ADDENDUM NO. 1

PROJECT: Renovations to L.S. Rugg Elementary
Alexandria, LA

PROJECT NO: 22027

ISSUED BY: Alliance Design Group, LLC

F6

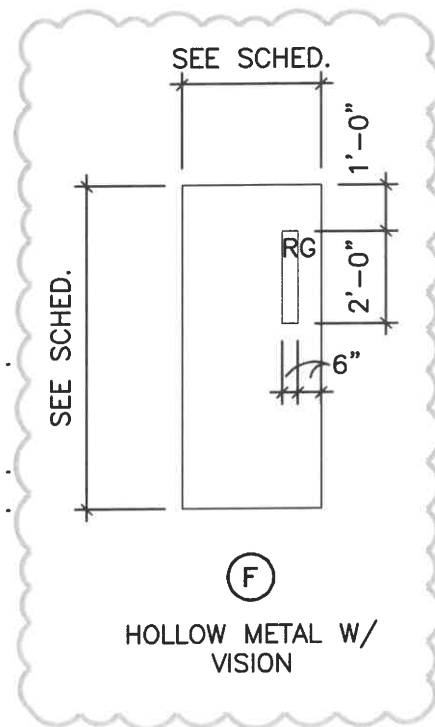
1. Add Wall Section F4 as shown on attached sheet.

1. On Building Section F1, provide callout for Wall Section F6/A-202 showing the connection to the existing building.

FYRE-TEC 900 (OR EQUAL)
W/ 20 MIN. GLAZING -
INTERCONNECT W/ FIRE
ALARM

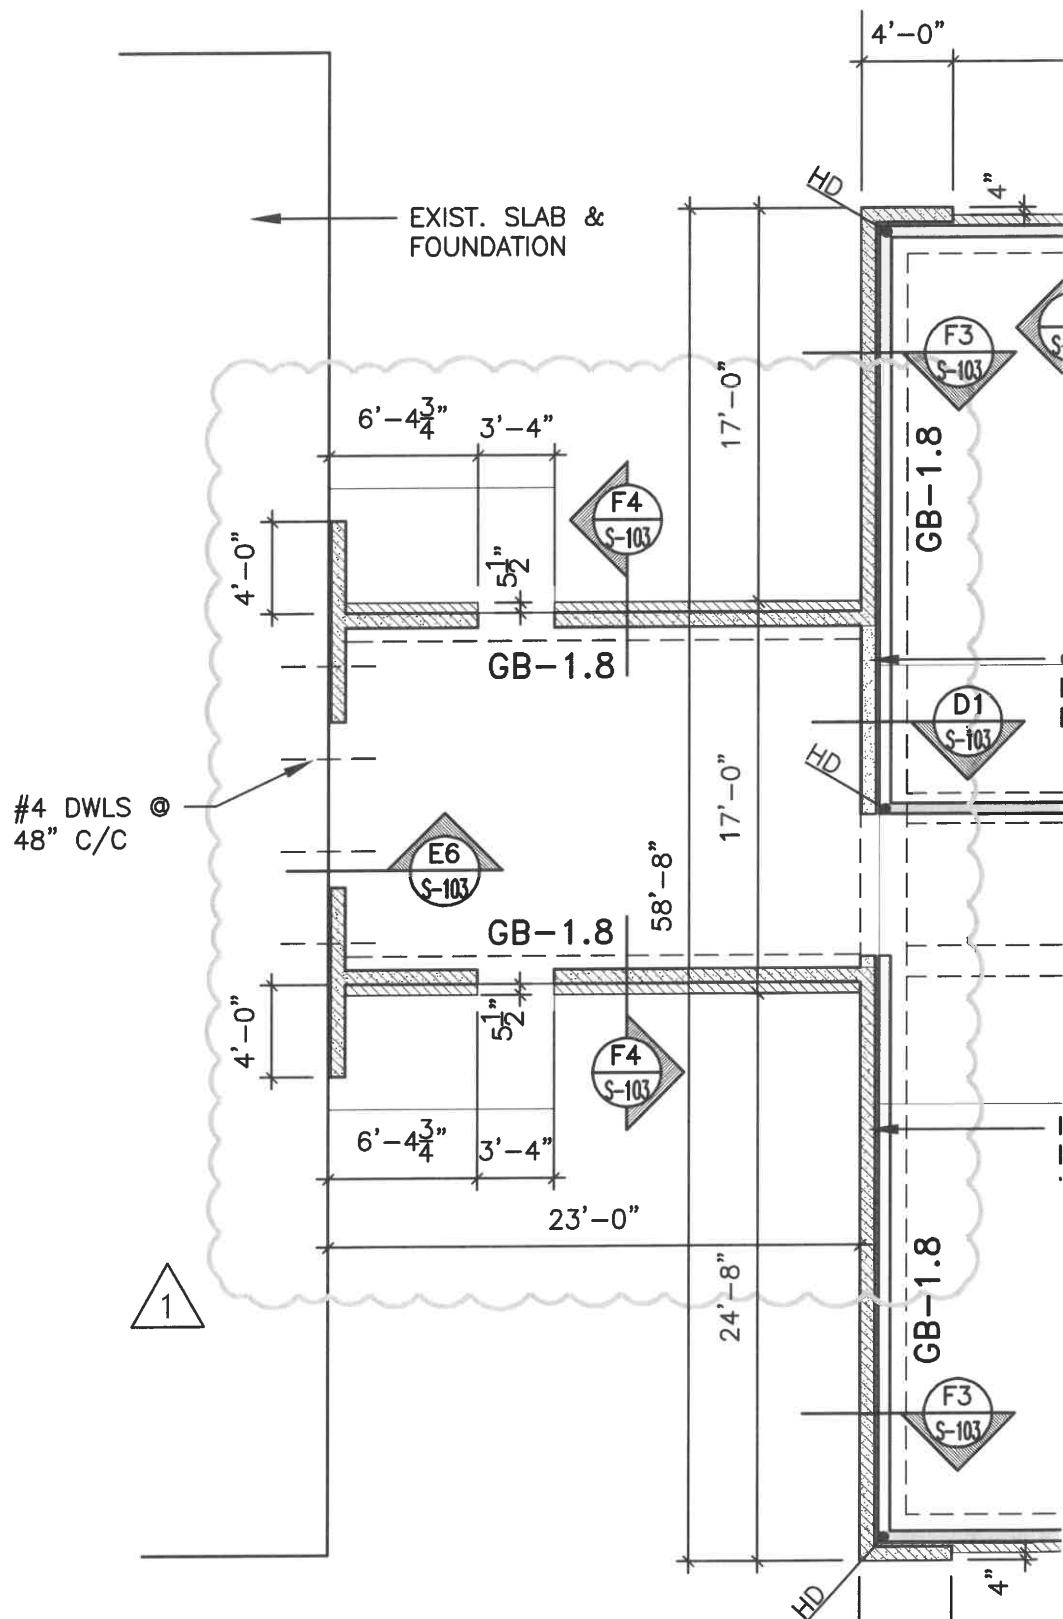
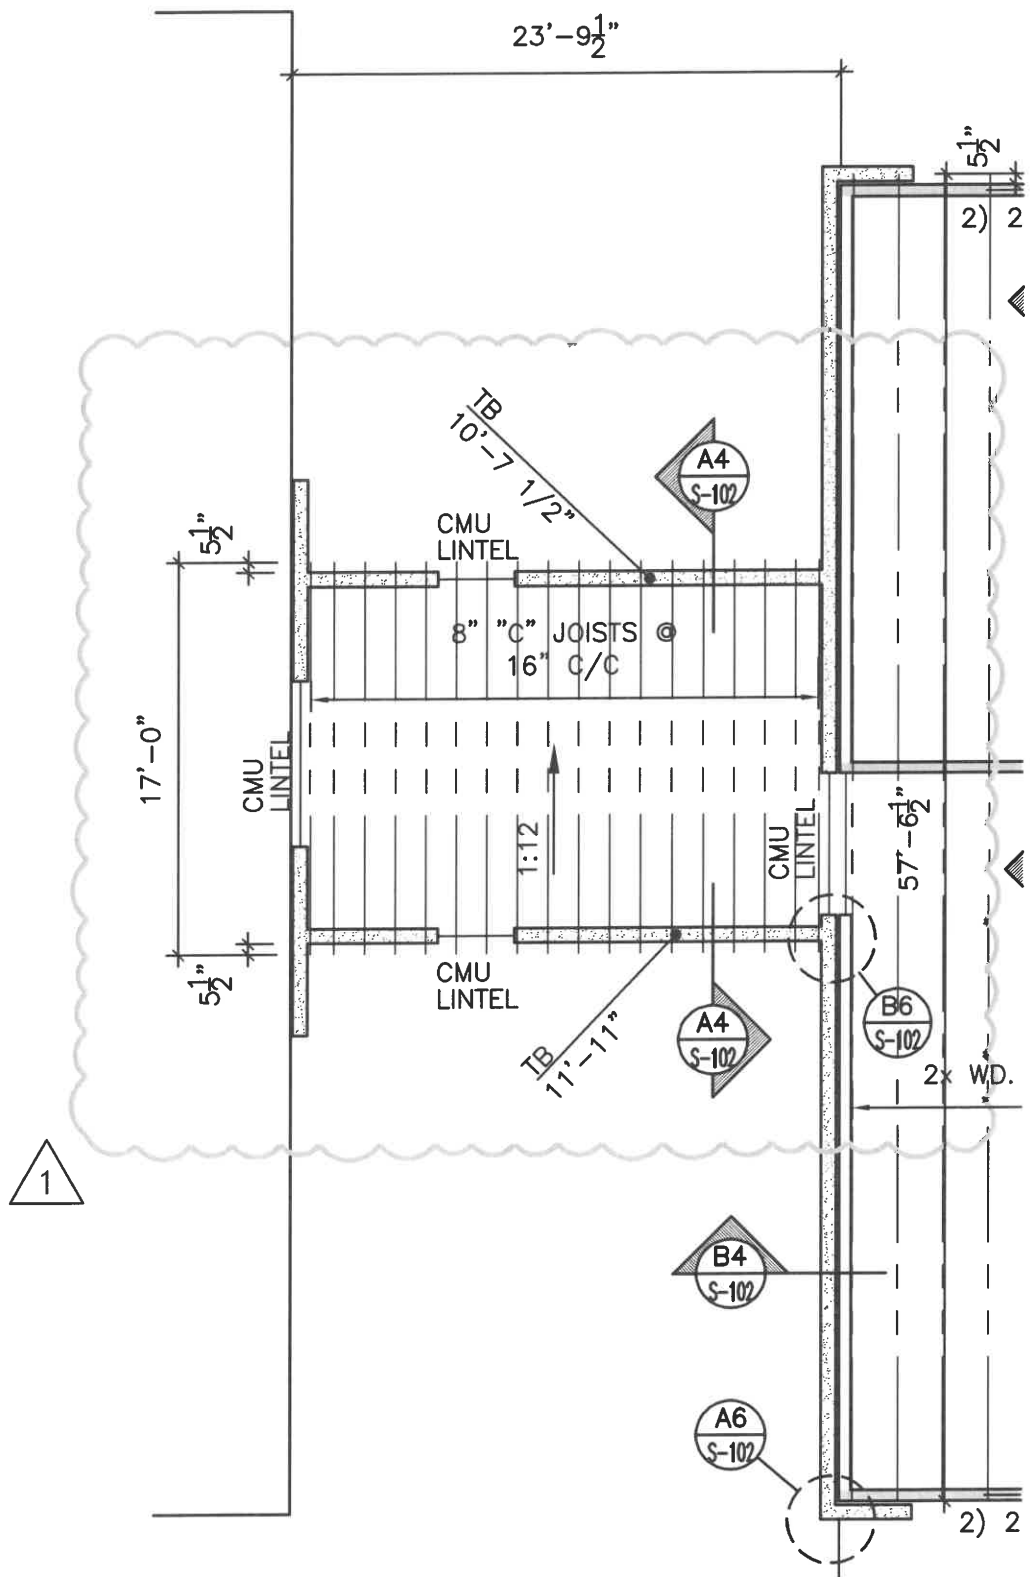
1. Revise window F to self-closing fire rated window as shown on attached sheet. Interconnect with fire alarm.
2. Revise window detail 9 & 10 as shown on attached sheet.
3. On Partition Type P-3, revise rated ceiling label to UL I501.
